- Subject: N212328980 Service Update Rear Fuse Block Cover Diagram Has Incorrect Fuse Information
- Models: 2021 Chevrolet Equinox 2021 GMC Terrain
- To: All General Motors Dealers

Service Update N212328980 Rear Fuse Block Cover Diagram Has Incorrect Fuse Information

Condition	Certain 2021 model year Chevrolet Equinox and GMC Terrain vehicles may have a condition where the rear fuse block cover diagram has incorrect fuse values.
Correction	Dealers are to add an adhesive label to the rear fuse box cover.

5758252

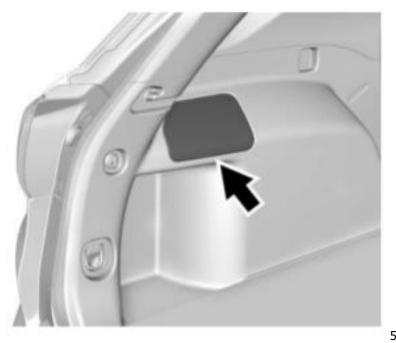
- 1. Remove the rear fuse block cover panel, shown here.
- 2. Clean the area where the label is to be applied using a non-oil-based cleaner such as isopropyl alcohol (rubbing alcohol), Kent Acrysol, P/N 20005, or an equivalent cleaning solvent or adhesive remover.

3. Install the new fuse block label as shown above.

4. Reinstall the fuse block cover panel.
